January 4, 2010

Mr. Reid Rosnick
Radiation Protection Division (6608J)
U.S. Environmental Protection Agency
1200 Pennsylvania Ave., NW
Washington, DC 20460
Via email: Rosnick.Reid@epamail.epa.gov

Public Issues, Concerns, Recommendations from June 30, 2009 EPA Meeting in Canon City, Colorado

Including Additional Comments

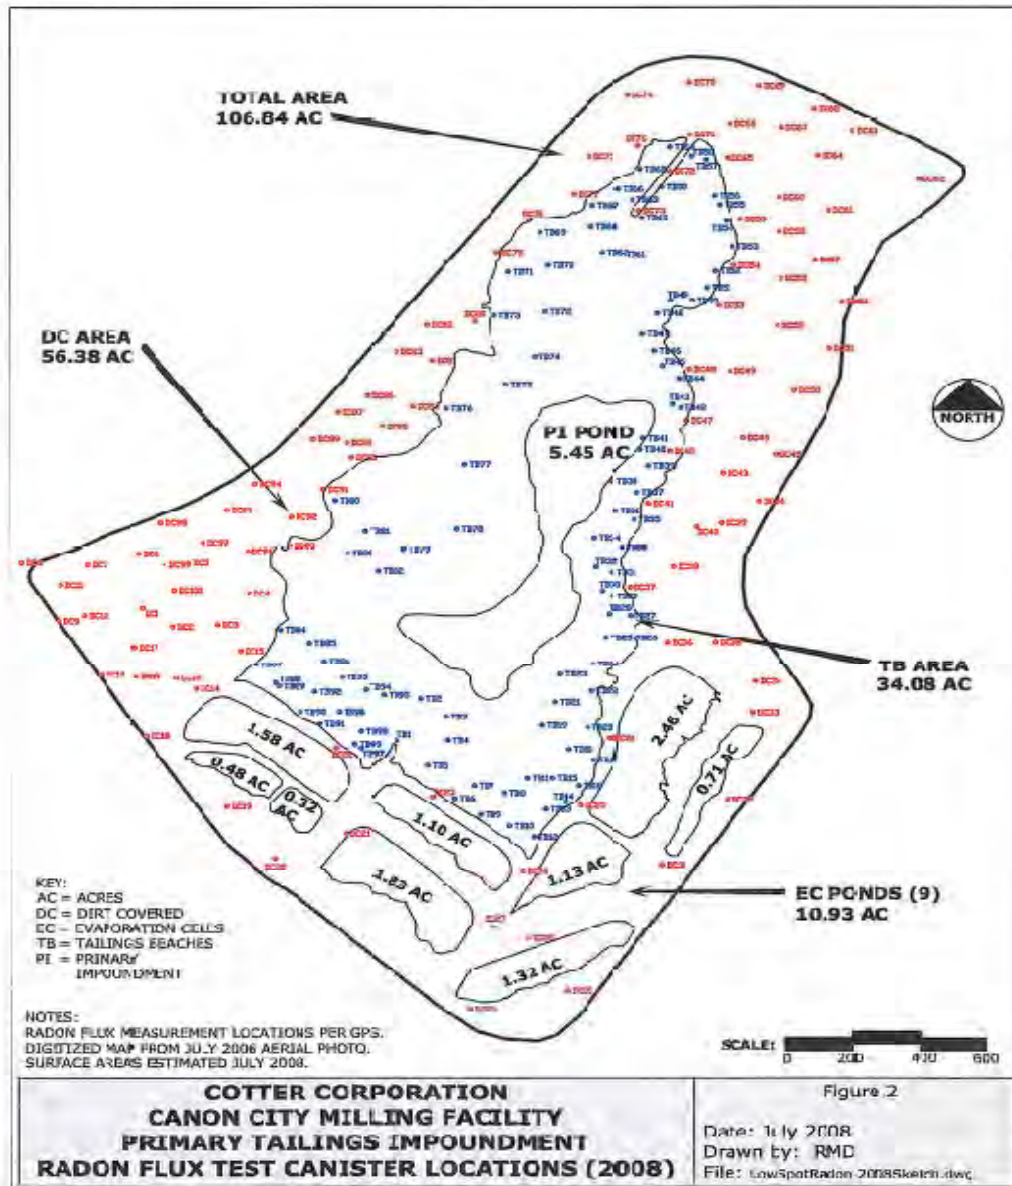
- i. **Case in Point:** Cotter Mill Primary Impoundment based upon 2008 data:
 1. 107 acres total, **NOT 40 acres**
 2. 56 acres dirt covered
 3. 34 acres exposed, **NOT 10 acres**

4. 17 acres water covered
 - ii. **Case in point:** Method 115 allows existing impoundments to have more than 10 acres of exposed tailings. Additional Cotter Mill Primary Impoundment data:

1. 2007: 29 acres exposed tailings
 2. 2008: 34 acres exposed tailings
 3. 2009: no data until March 2010 even though measurements were taken in July 2009!

- b. For “Existing Impoundments” greater than 40 acres: The number of canisters required for thorough radon flux measurement must be scaled to the total acreage to account for the fact that varying conditions exist at each specific mill site, and to conform with public protection found in other areas of these regulations.
- c. For “Existing Impoundments” greater than 40 acres: The amount of exposed tailings should not be allowed to exceed 10 acres in order to provide equal protection to all citizens whether living near an existing (pre-1989) tailings impoundment, or a newer impoundment. We believe this to be an environmental justice issue.

COTTER CORP.
 CANON CITY MILL
 MAIN IMPOUNDMENT
 AS-BUILT DRAWING OF
 EVAPORATION CELLS
 AND
 DEWATERING-DRAIN SYSTEM
 1" = 330'

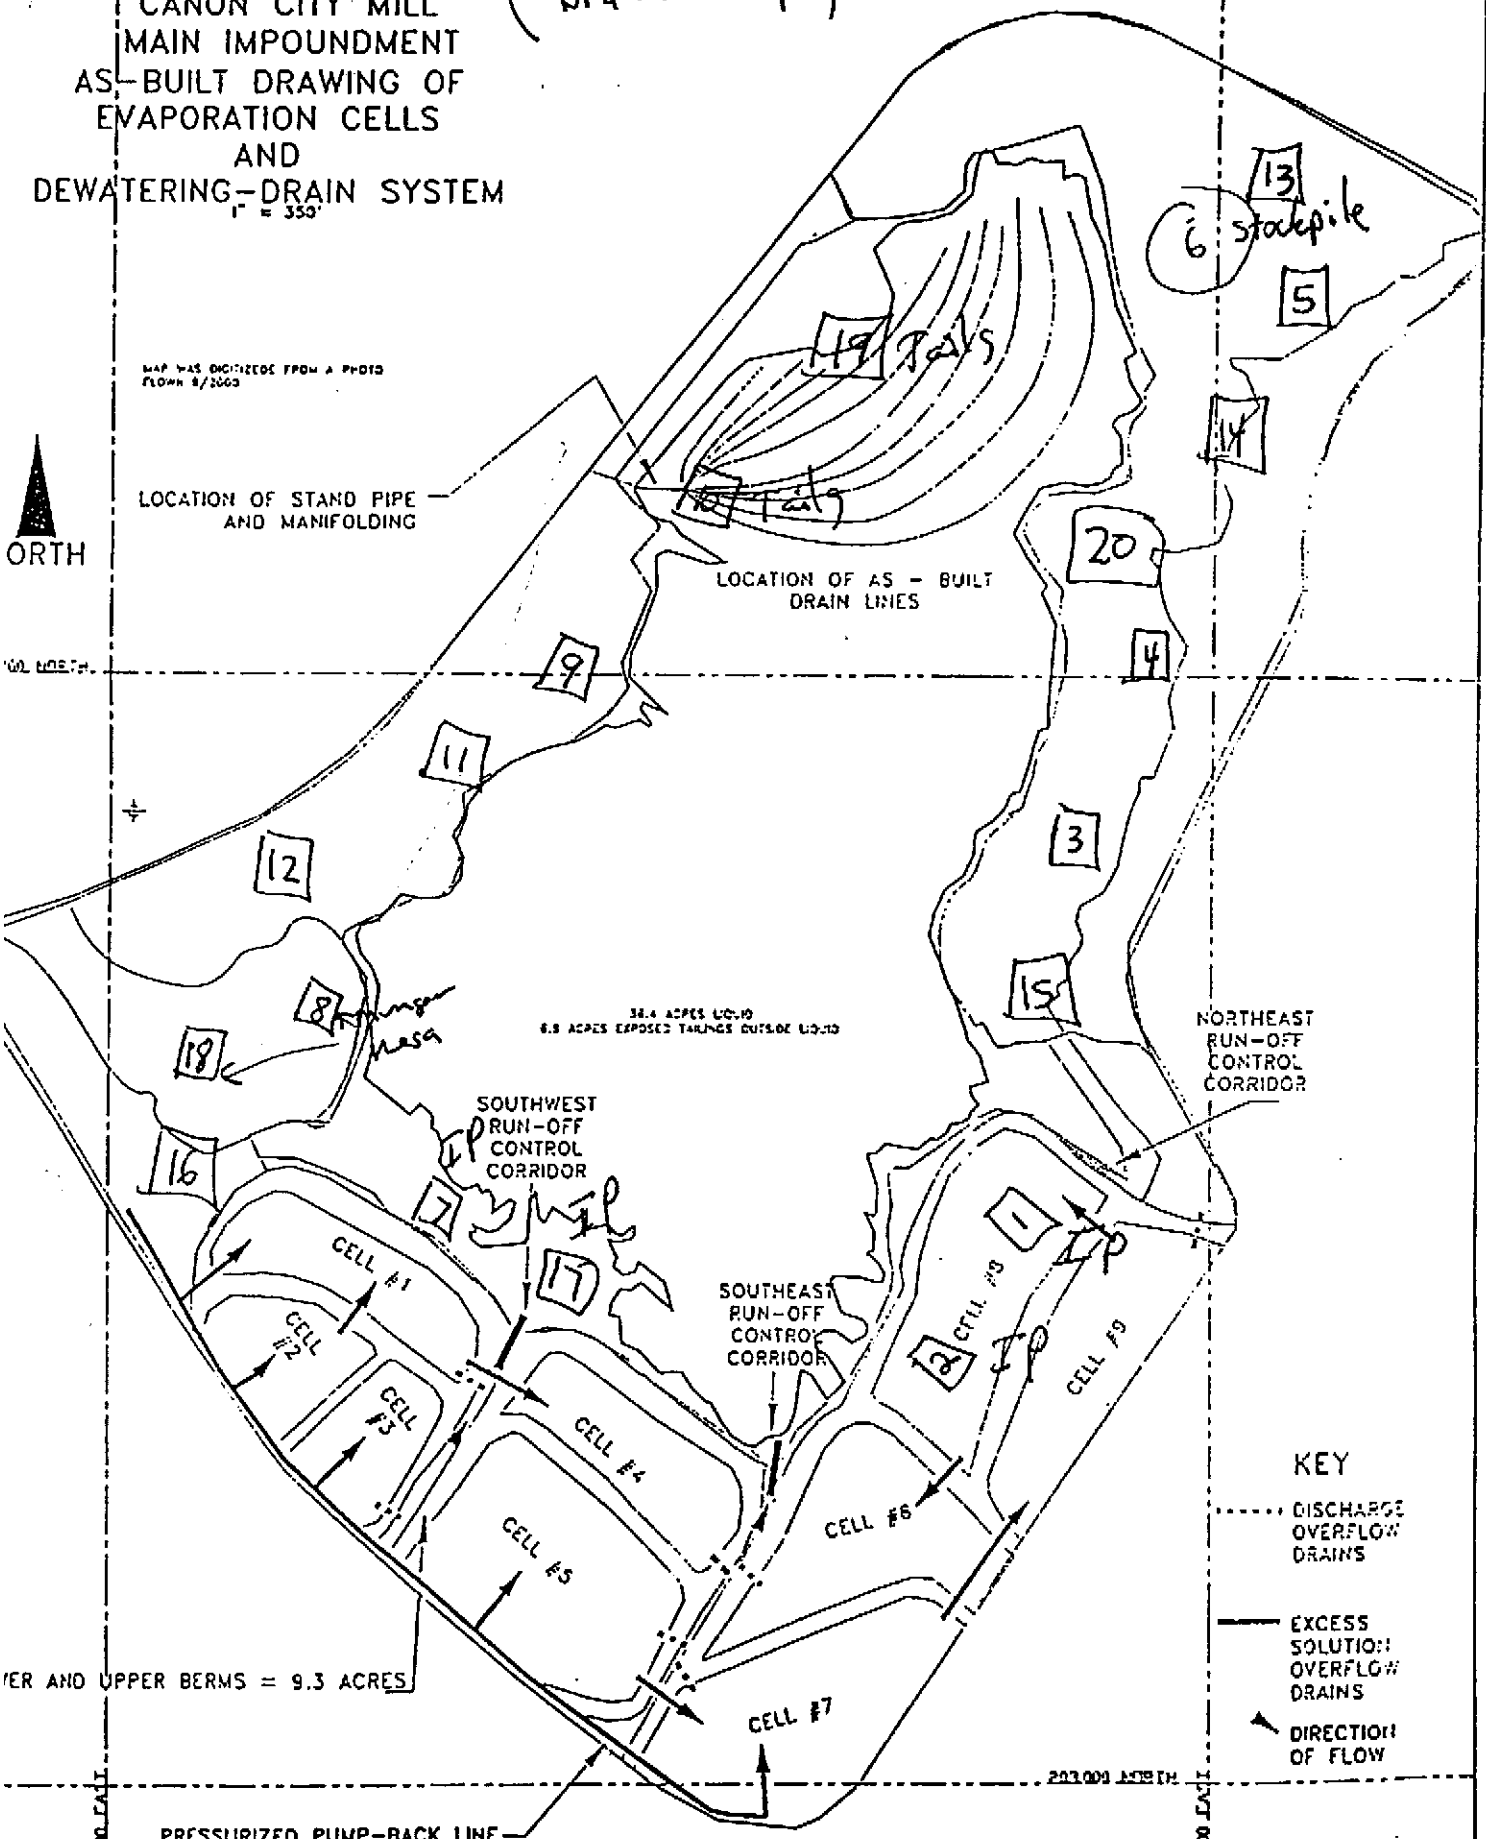
- a. While the Cotter Mill is not an ISL facility, they too have evaporation ponds that can vary significantly in water coverage throughout a year and contribute to radon flux. Soil samples MRA1 and MRA2 taken from Cotter's Evaporation Cell #8 in 2002 show high concentrations of Alpha emitting material (see **Reference – 4**). The test procedures and collection requirements requested by EPA in the May 5, 2009, letter are certainly more thorough than any annual testing performed at the Cotter Mill. An average of two charcoal canisters per each of Cotter's evaporation ponds over a 24-hour period once a year certainly is not as representative of radon flux emissions as the requested procedure would be, nor does it measure radon at 1, 2 or 3 meters above the pond (see **Reference – 5**). Results of this sort of radon testing would answer many radon questions from citizens living near a tailings impoundment with evaporation ponds.

- b. It was extremely disappointing to hear EPA seemingly unconcerned that Cotter objected to the measurements they were asked to provide regarding their evaporation ponds on the grounds that they were not an ISL facility. It is difficult to understand why an acid or alkaline leach conventional mill, especially those close to a large population, would be held to a lesser standard of investigation than an ISL facility. **Cotter should be required to provide the requested information.**
